# CENTRAL VALLEY FLOOD MANAGEMENT PLANNING PROGRAM

## **Errata to the Public Draft**

**2012 Central Valley Flood Protection Plan**

**June 2012**

#### 21. Section 2.4.1, page 2-8, Figure 2-2

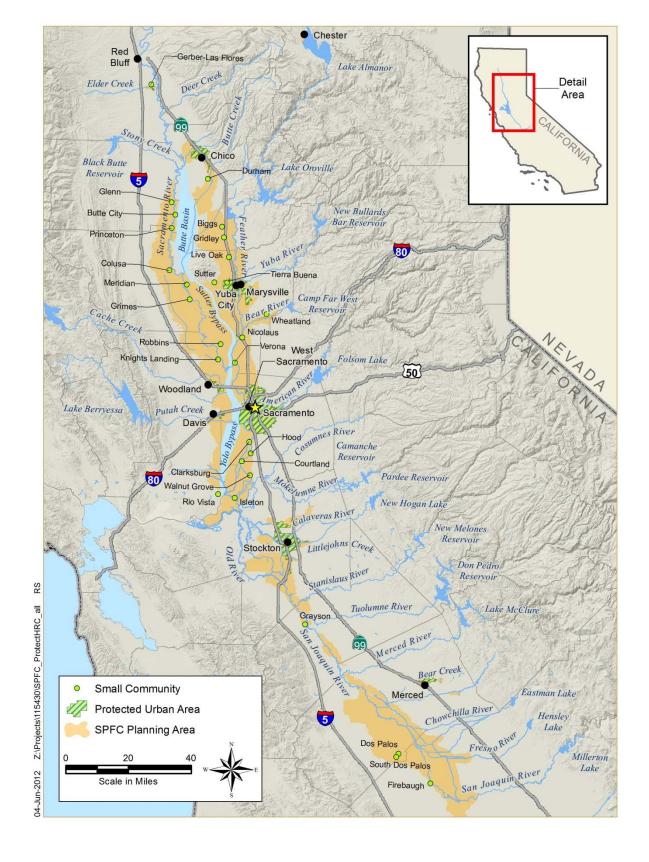
Figure 2-2 "Urban Areas and Small Communities Included in Protect High Risk Communities Approach" is replaced by the following:

#### 23. Section 2.5.1, Page 2-11

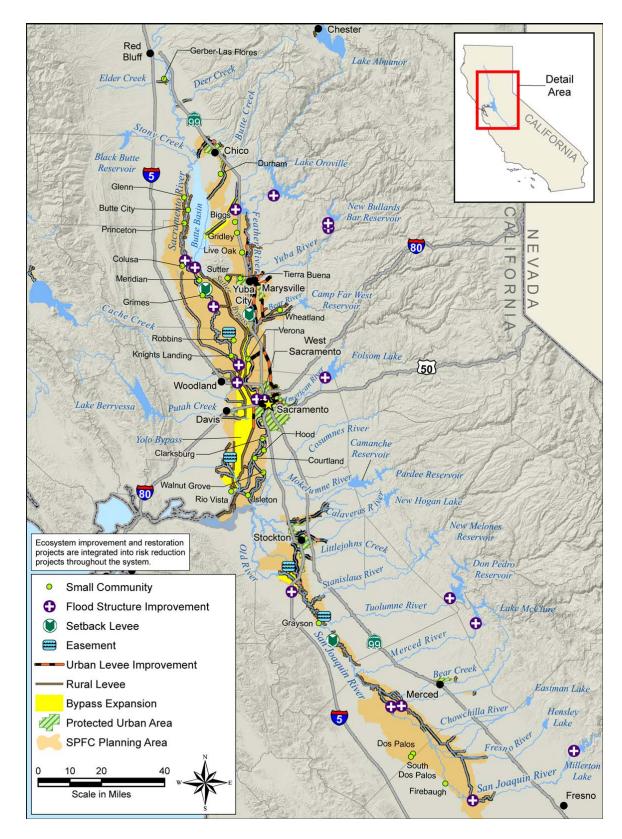
Figure 2-3 "Improvements Included in Enhance Flood System Capacity Approach" is replaced by the following:

Figure 5-1. DWR Vegetation Inspection Criteria for Standard Levees –Long Waterside Slope and Landside Berm Vegetation Management for Existing Levees – Long Waterside Slope and Landside Berm

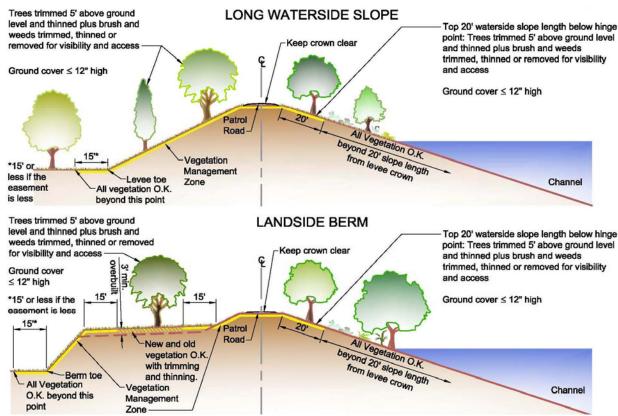
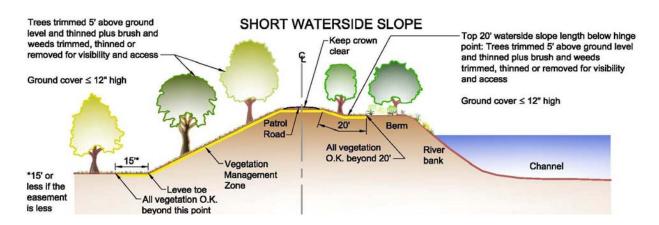
Replace Figures 5-1 through 5-2 and the figure titles with the following:

Trees and other woody vegetation may be: (1) planted, and (2) allowed to naturally revegetate on a landside planting berm. Only the portion of the landside planting berm that is both 15 feet or more from the landside levee slope and 15 feet or more from the landward top of the planting berm may be planted and allowed to naturally revegetate. All trees and other woody vegetation in this area of the planting berm must be trimmed up 5 feet above the ground and thinned for visibility. Any landside berm can be a planting berm if its top is more than 30 feet wide (as measured perpendicular to the levee centerline) and the berm is at least 3 feet thicker than required for levee integrity (to account for potential overturning of trees from windthrow) (see Figure 5-1).

Trees and other woody vegetation may be planted on a waterside planting berm below the vegetation management zone, and on natural ground more than 20 feet (slope distance) waterward of the waterside levee crown hinge point.

Figure 1-1. Flowchart for Cities and Counties to Makeing Findings Related to an Urban Level of Flood Protection

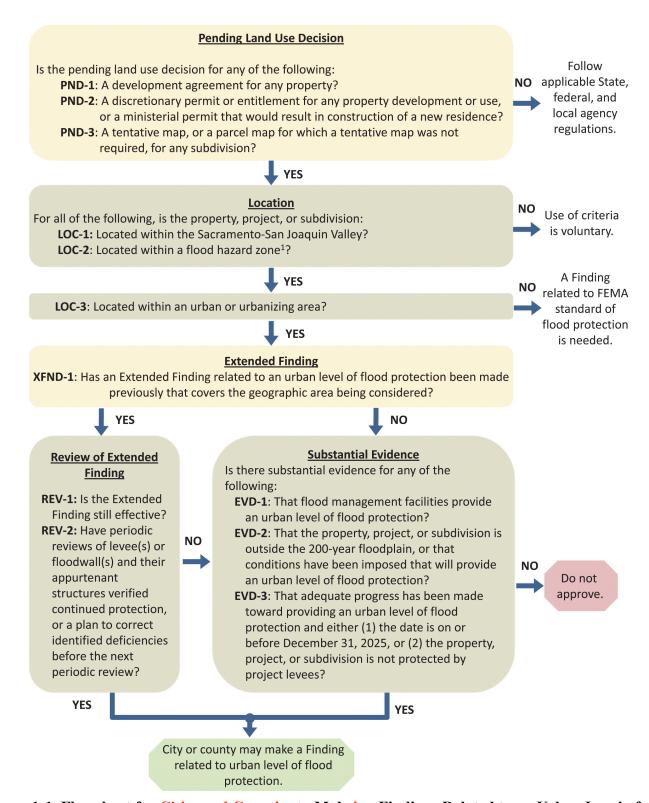
Replace Figure 1-1 with the following:
